Manual Supplement

Manual Title: 1745 Users
Part Number: 2560366
Print Date: April 2006
Revision/Date: 1, 7/06

Supplement Issue: 5
Issue Date: 3/11
Page Count: 4

Using the Optional Microclamps

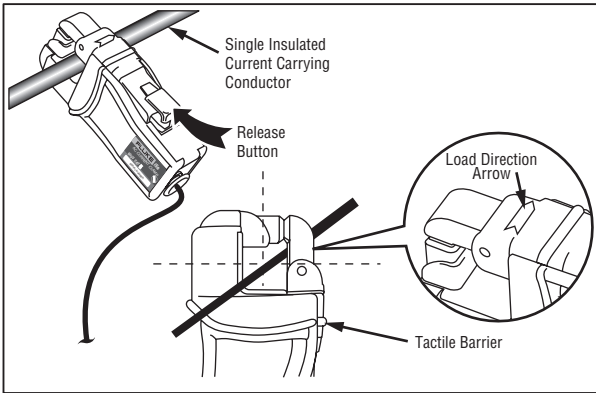
On page 16, under **Connecting the Logger** add the following text and Figure:

- **To avoid shock or personal injury, keep fingers behind the tactile barrier, see the figure.**

Locking the Coil

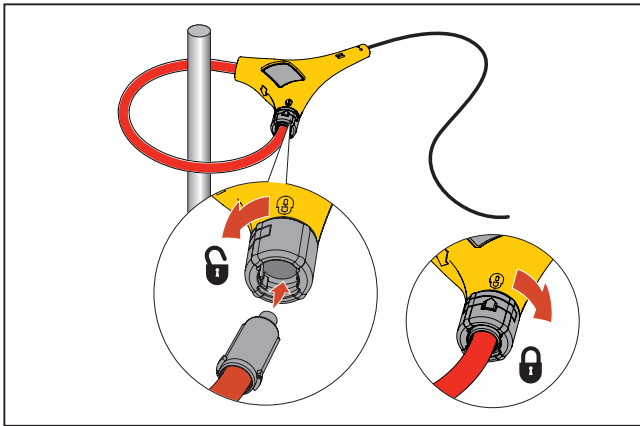
On page 18, following the Note, add:

1. Connect the Probe to the 1735 via the current input socket.
2. Wear protective equipment or de-energize the circuit and place the Probe around the conductor under test. To lock the coil, see the Figure.
3. Re-energize the circuit.
4. Observe and take measurements as required. Positive output indicates that the current flow is in the direction shown by the arrow on the Probe.
5. Wear protective gloves or de-energize the circuit before removal of the Probe.
